## **APPENDIX D**

### **Public Involvement Process**

## ***Upper Southeast Salt Creek Trunk Sewer Open House*** ***March 4, 2004***

## ***Preliminary Routing/Corridor Study and Design of Upper Southeast Salt Creek Trunk Sewer for the Lincoln Wastewater System***

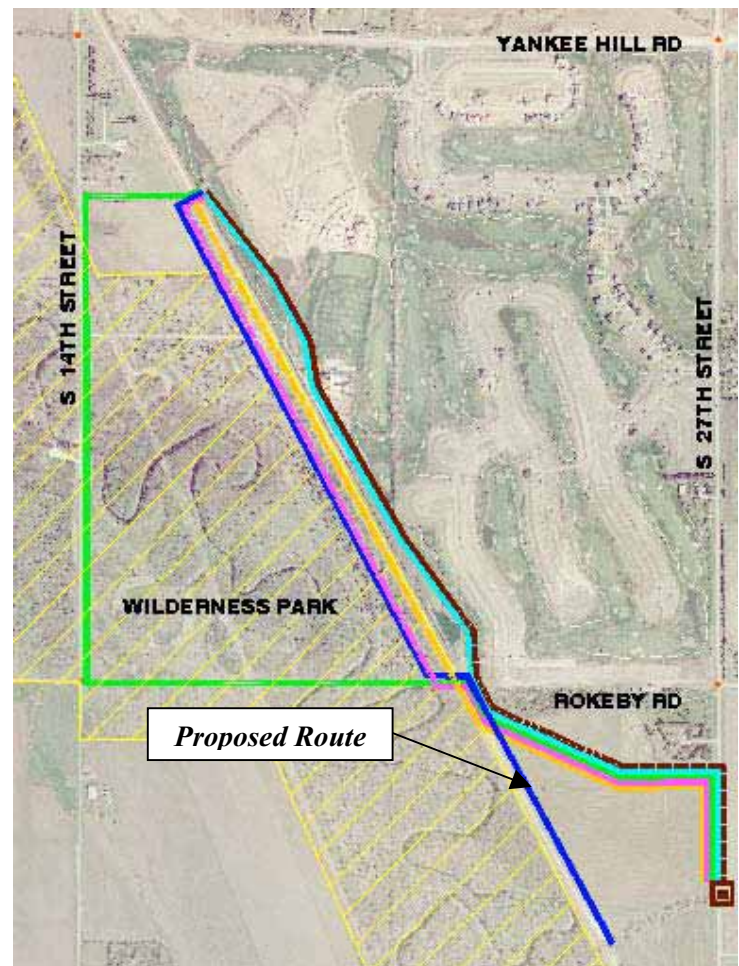
**Dark Blue (Proposed Route)** – gravity sewer line, open cut through Wilderness Park.

- The trunk sewer will pass through a section of Wilderness Park that was formerly agricultural fields, currently overgrown with brome grass and scrub trees.
- After construction, the affected area could be returned to natural prairie grass and wildflowers.
- A diagonal bore under the RR at the upstream end could be used to avoid old growth trees and a Salt Creek oxbow.
- There is potential for tunneling under portions of Wilderness Park where sensitive areas are identified.

Can the railroad crossover be moved north to avoid the bur oaks and the Salt Creek oxbow?

Q: What are the options for crossing the railroad tracks at the south end?

A: Right now three options are being evaluated for crossing the railroad at the south end.

1. Boring under the RR north of the existing stand of bur oak trees into a stormwater detention cell on the golf course side. This would require a deep bore pit and might involve going through sandstone. It would also require crossing under the drainage ditch directly south of the golf course and avoiding the existing storm sewer outlet.

2. Boring under the RR north of the existing stand of bur oak trees, and end up south of the existing drainage ditch south of the golf course. The railroad typically requires that pipelines cross the tracks at a 90° angle. They may allow some deviation to that, but probably not much. If this is the case, this option would not be feasible.

3. With as minimal impact on the bur oaks as possible, bore under the RR farther south ending up in the field south of the golf course. This would allow the required railroad crossing angle to be met, would hopefully avoid the sandstone, and would not require crossing the drainage ditch and avoiding the existing storm sewer.
